# River Knoll

## Draft Environmental Impact Statement

To: Ching Wah Chin, Chairman,  
and the Town of Ossining Planning Board

The subject proposed DEIS was reviewed against the Final Scope (the “Scope”) for the Draft Environmental Impact Statement dated July 20, 2016 adopted by the Town of Ossining Planning Board as Lead Agency. We performed the review for the purpose of determining whether the document is complete with respect to scope and content.

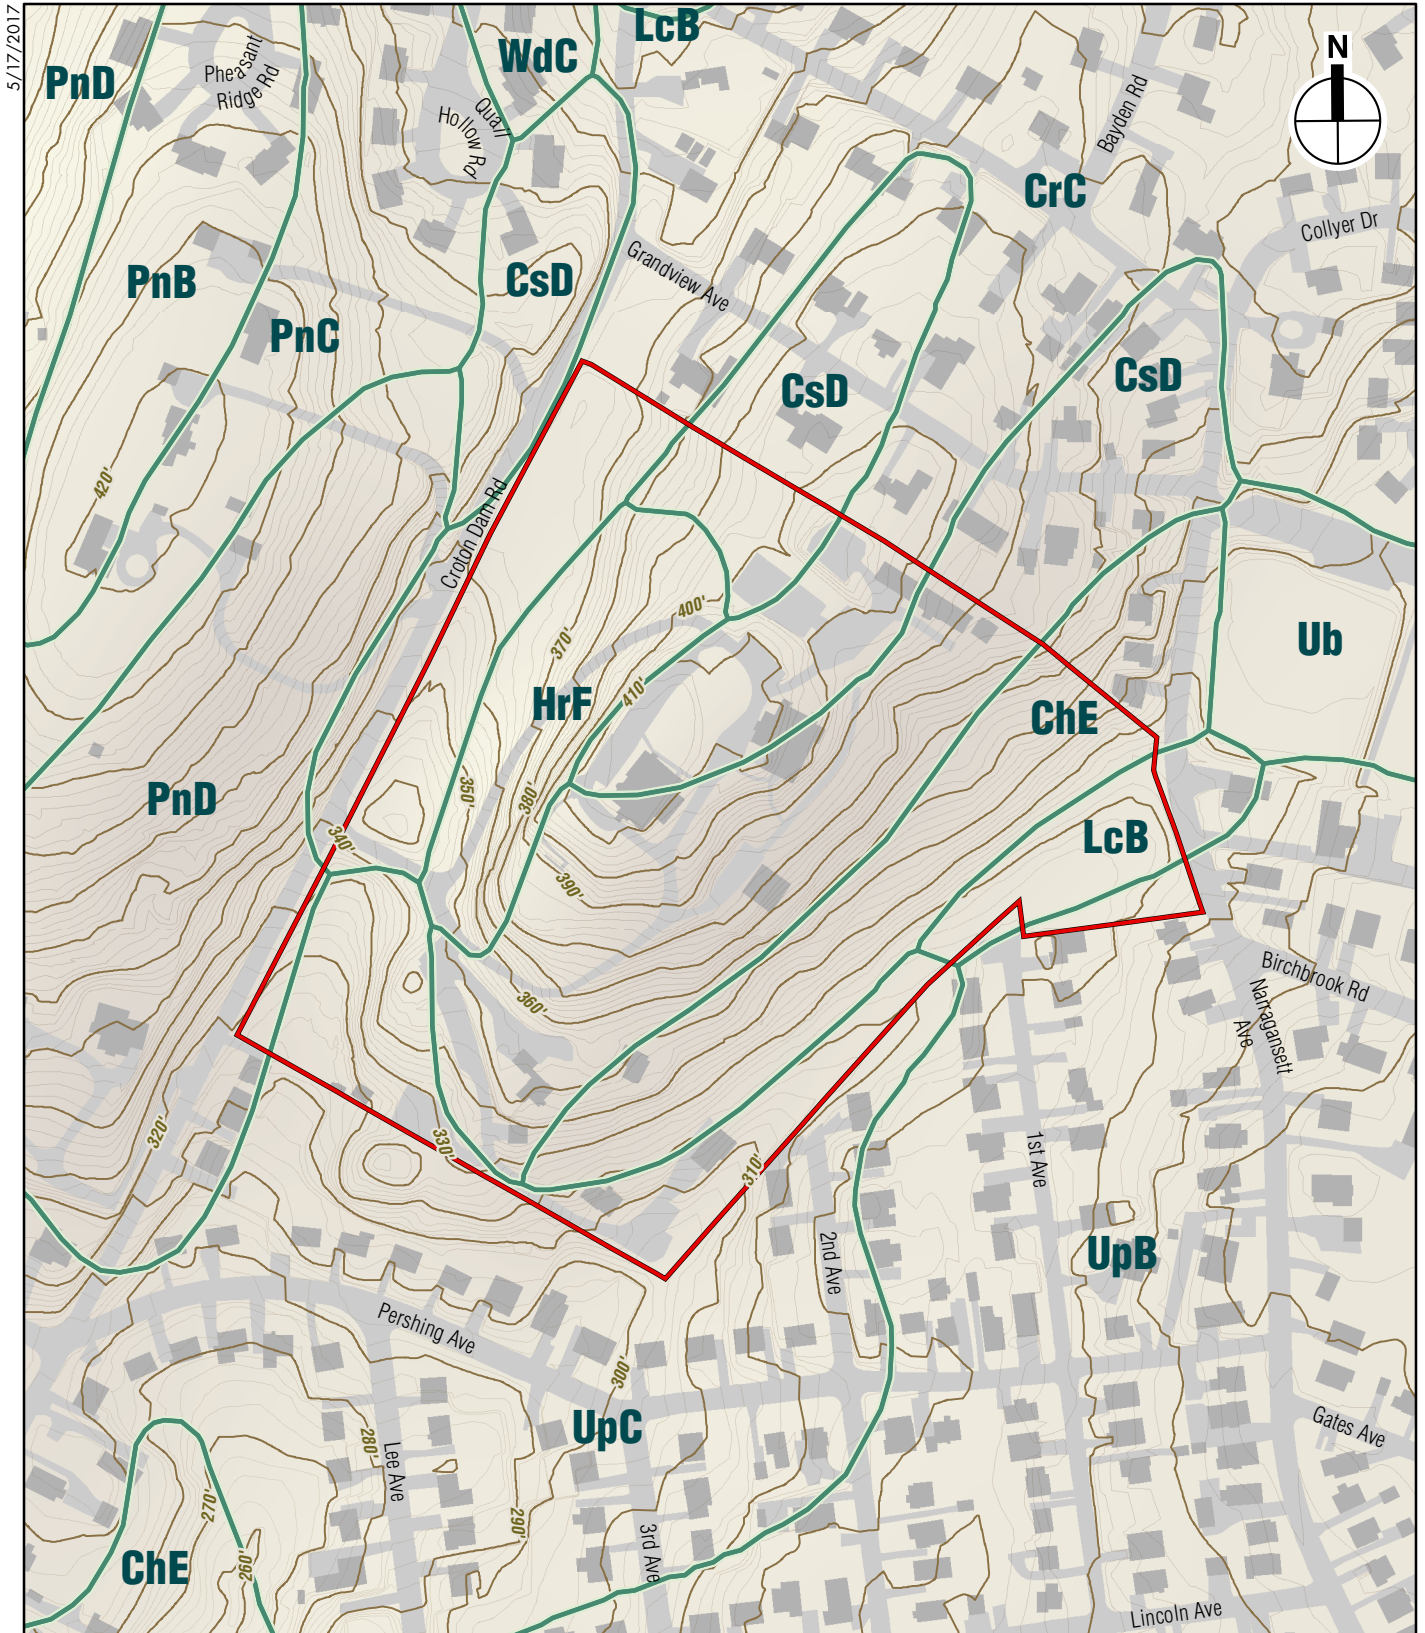
24. Figure 3.B-1: This figure is referenced in the narrative regarding locations of soil types on the property and is labeled “Soils and Topography.” However, it does not show the soil type boundaries on the site, which should be corrected. *(Scope Chapter III.B.1)*  
*See updated Figure 3.B-1.*
25. Page 3B-3, Section titled Steep Slopes: The narrative references “Figure 3.B-3,” which is missing from the document. The missing figure should be included in the document. *(Scope Chapter III.B.1) Figure added*

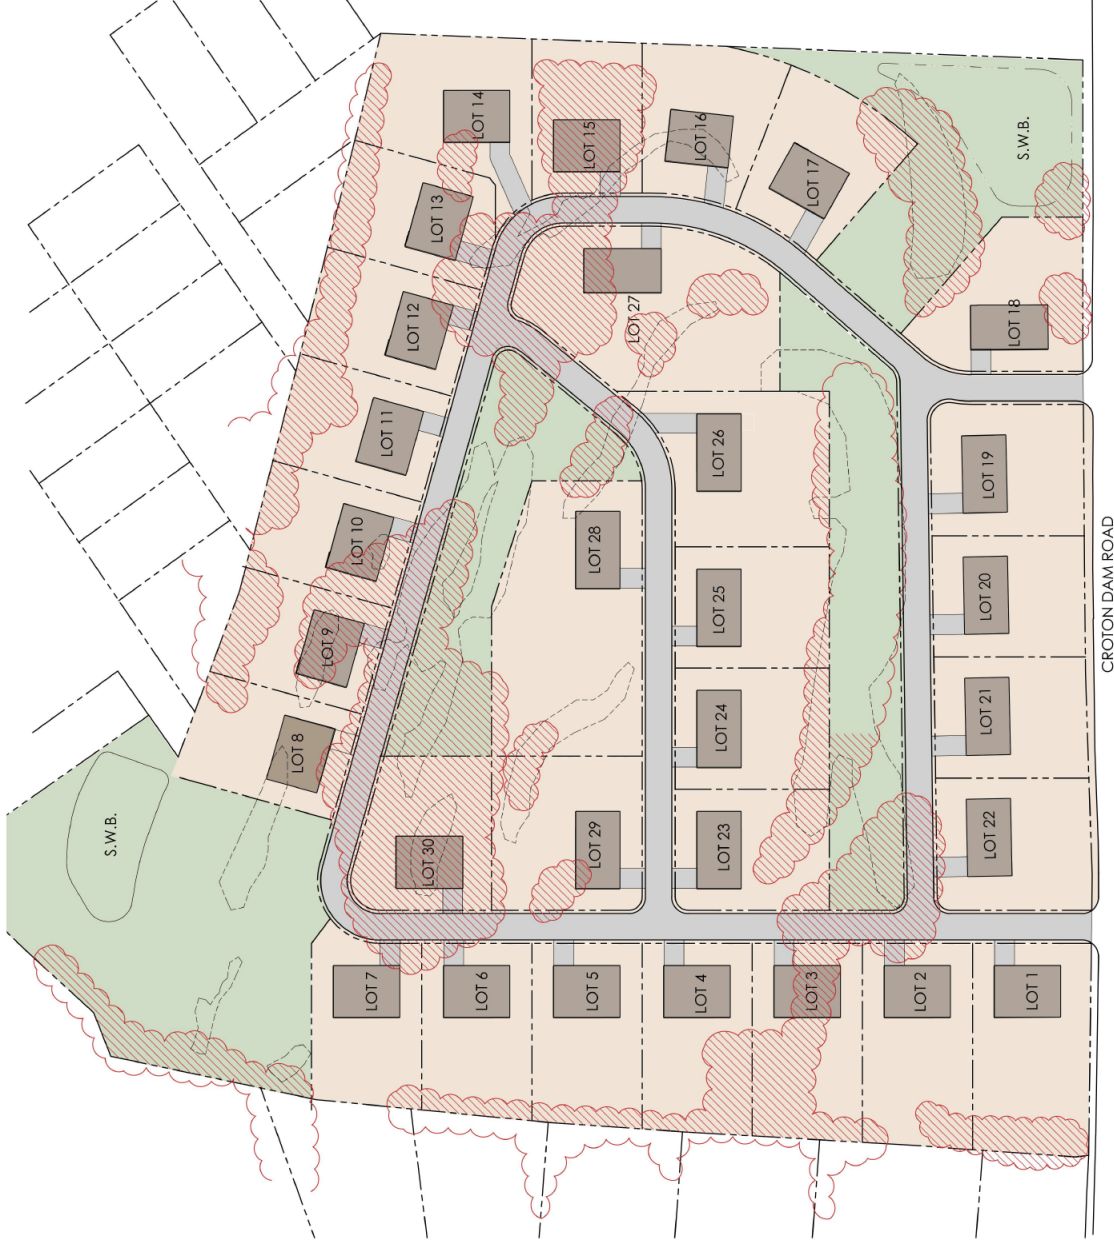
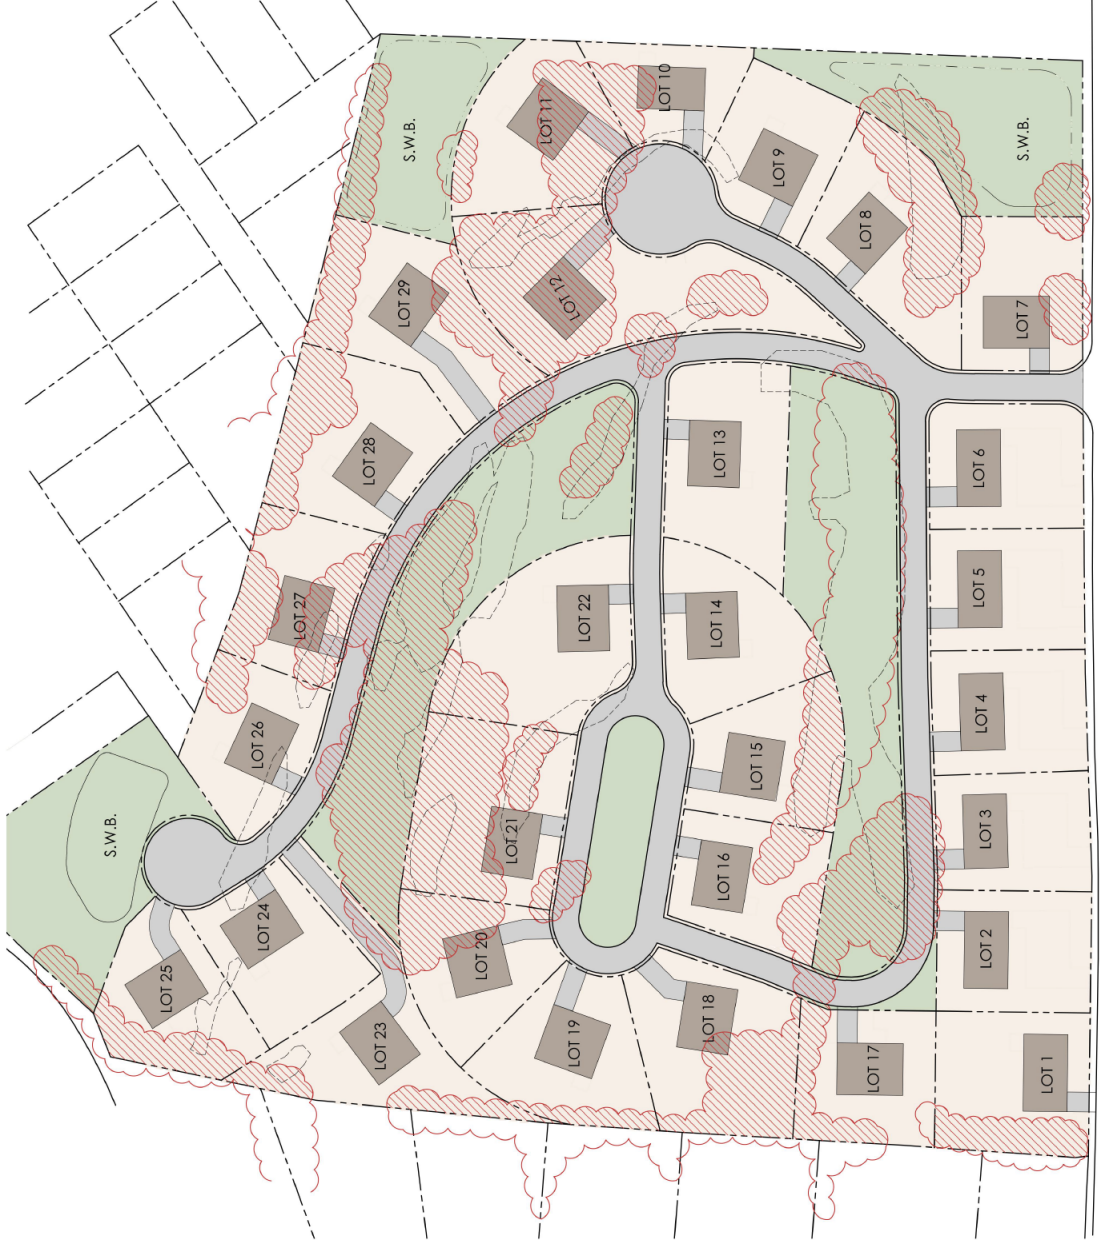
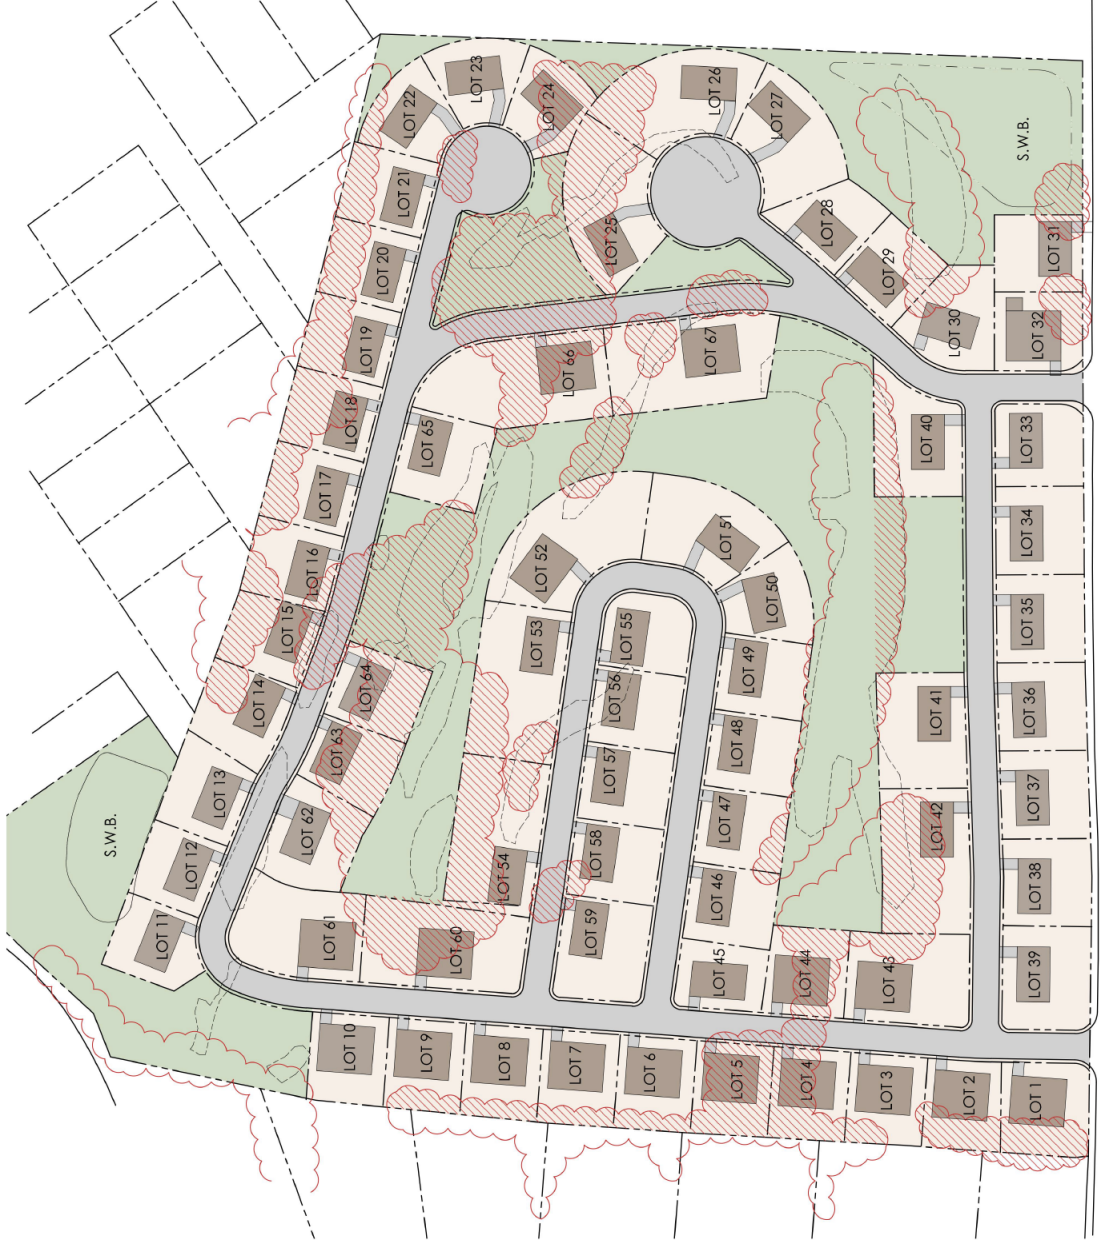
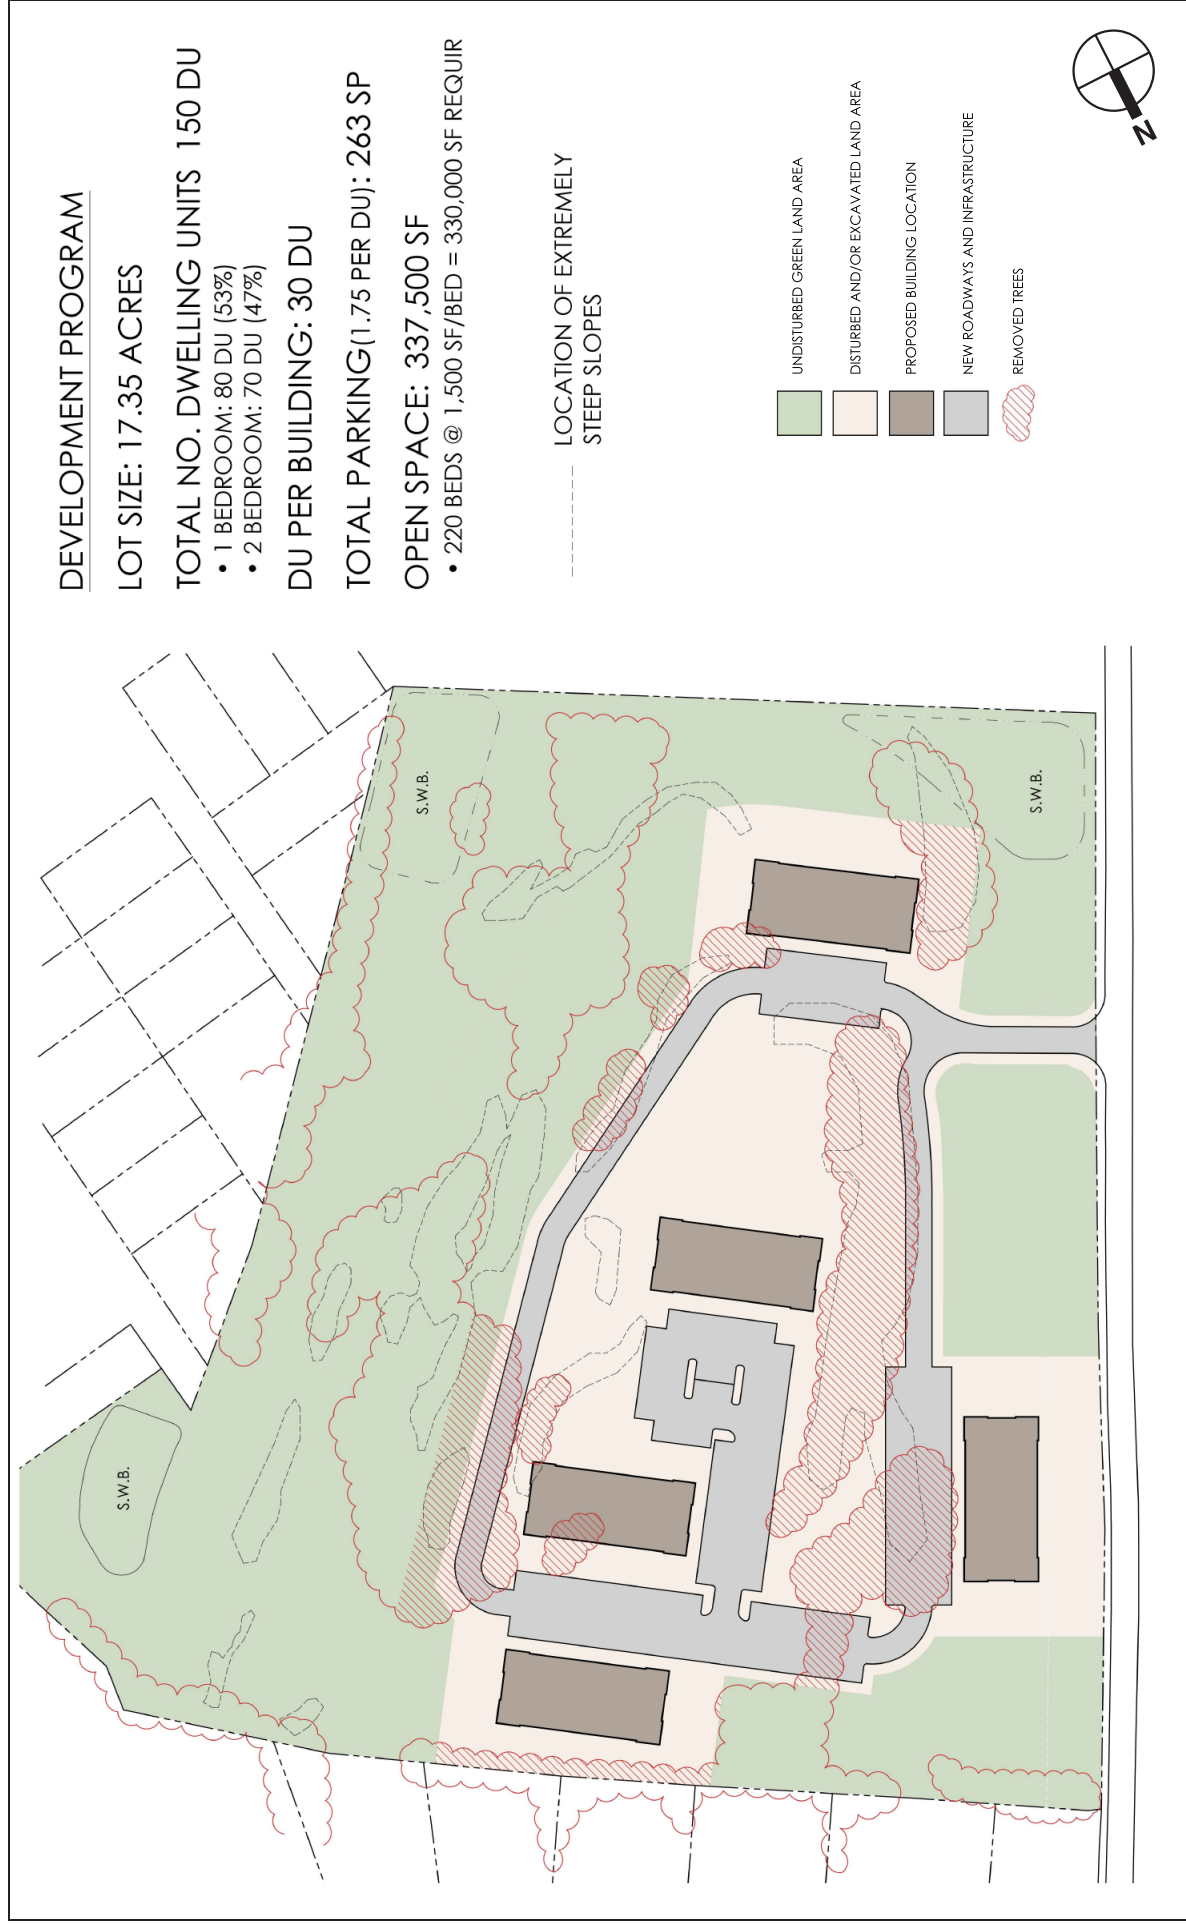
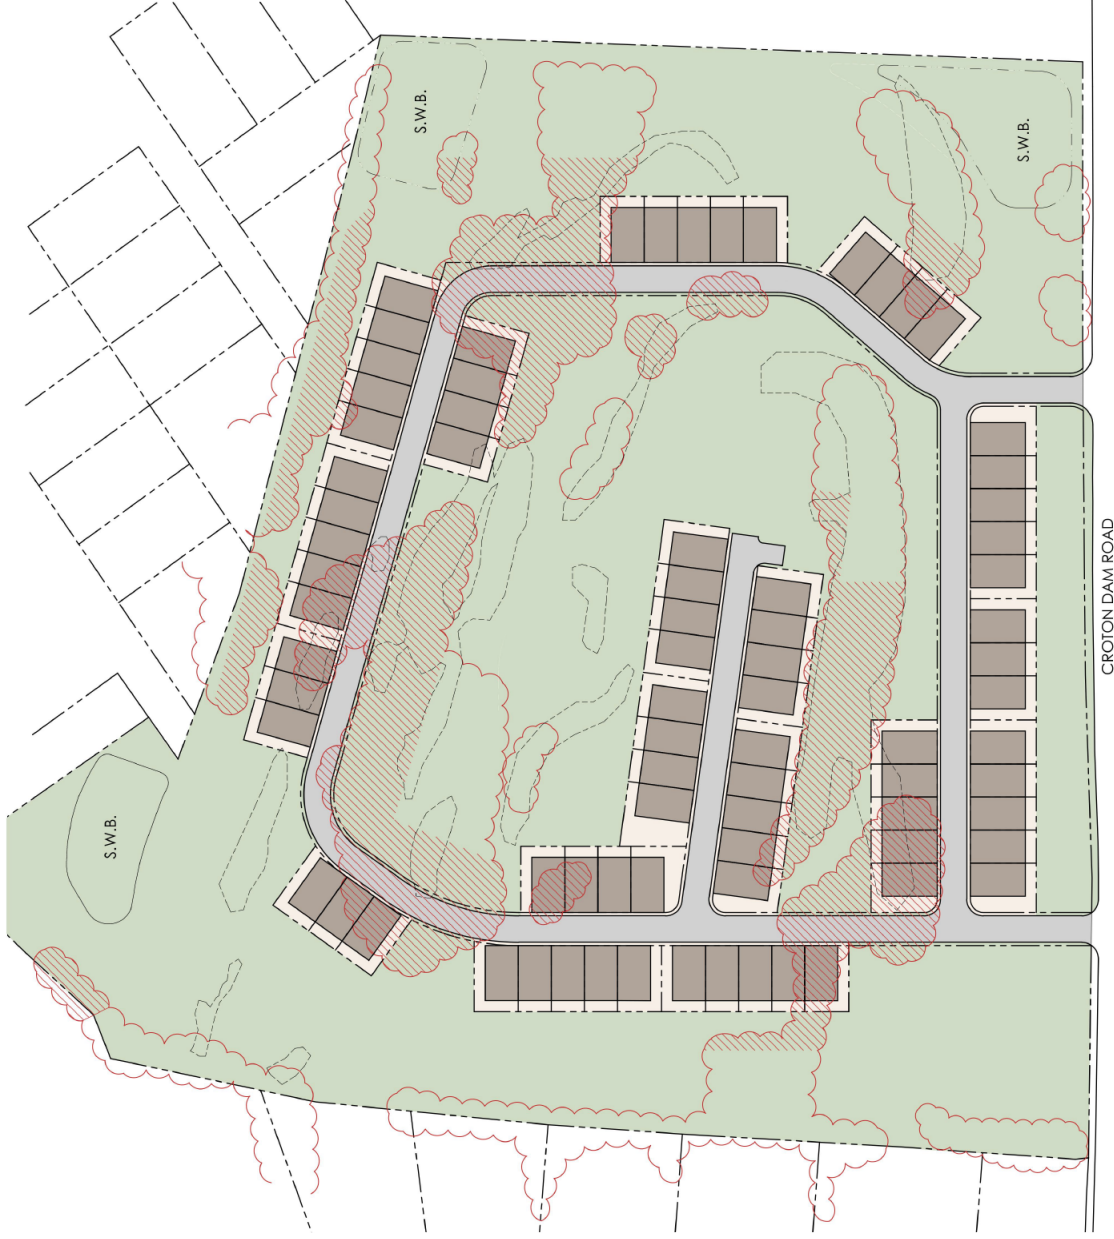
66. Entire Chapter 5, Alternatives: Each of the alternatives required by the Scope must be depicted graphically on plans, otherwise the section is incomplete. There should be a full-sized

73. Site plans for each of the alternatives required by the Scope should be provided. (*Scope Chapter V) Site Plans for six of the eleven alternatives are provided within the revised DEIS.*
